REC-10-02

Retrofit Emission Control Devices (REC)

Draft new Regulation on uniform provisions concerning the approval of Retrofit Emission Control Devices (REC) for heavy duty vehicles, agricultural and forestry tractors and non-road mobile machinery (NRMM) equipped with Compression Ignition engines.

Draft rev.00 Version 1 dated 27.03.2011 *Note: based on clean copy of previous draft for clarity.*

Annex 3.
Arrangement of the REC type approval mark

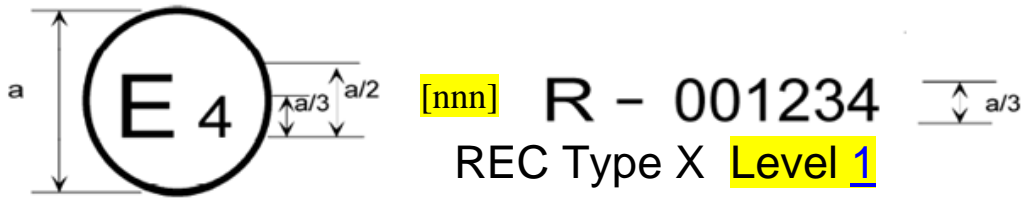
Comment [JMY18]: Possibility of retaining levels to be reviewed with the GRPE secretariat.

Test sequence for particulate reduction-REC

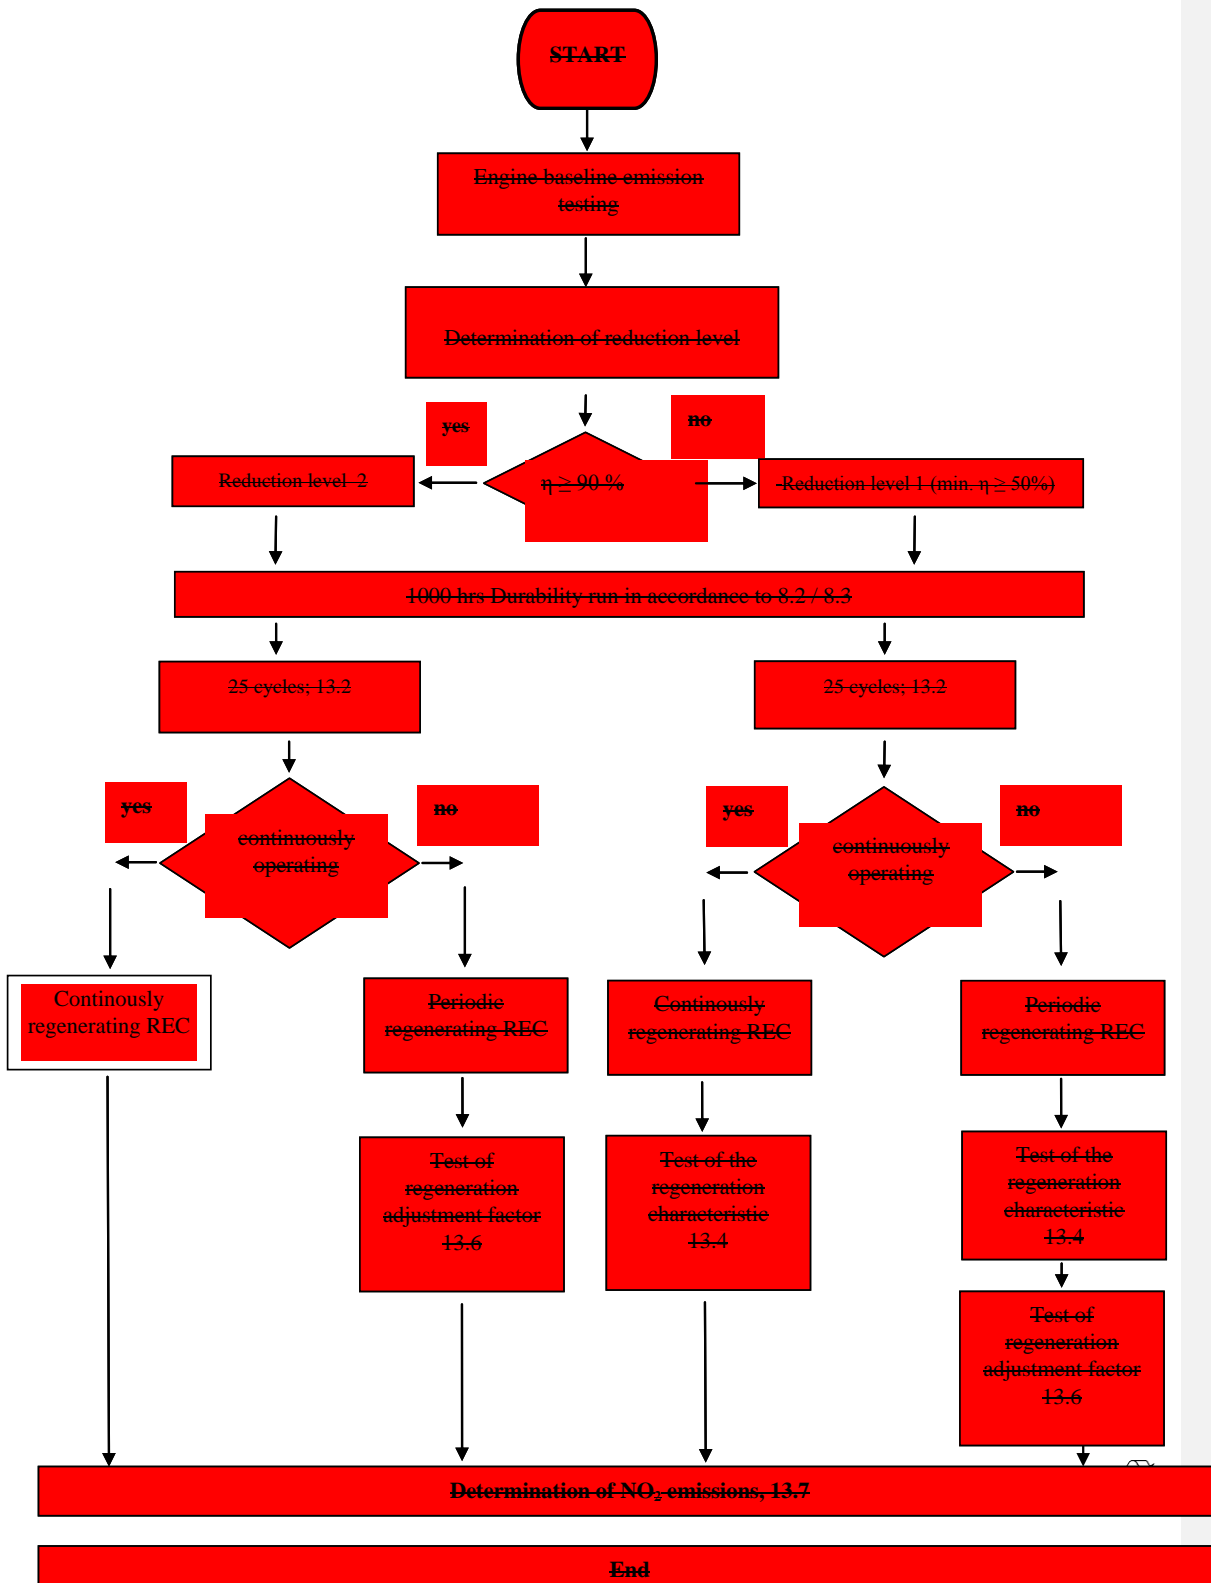
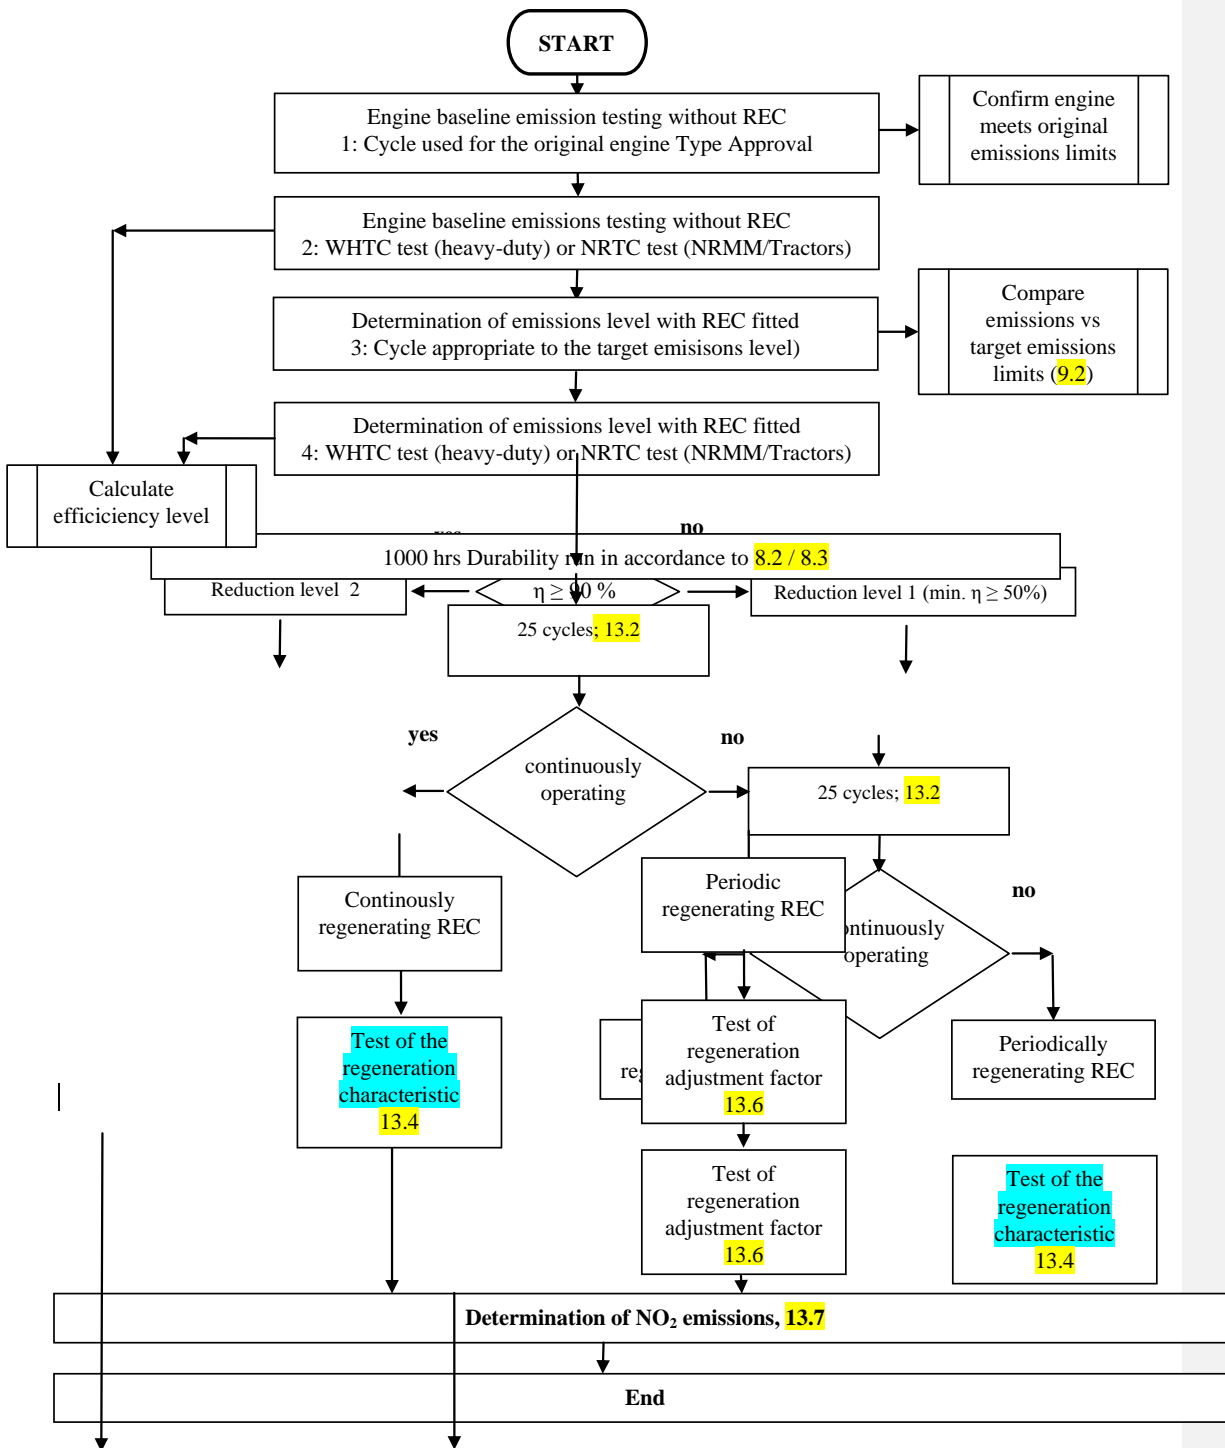
Comment [JMY27]: Can PM & NO_x reduction be combined in 1 flowchart? Chart to be reviewed when rest of document finalised.
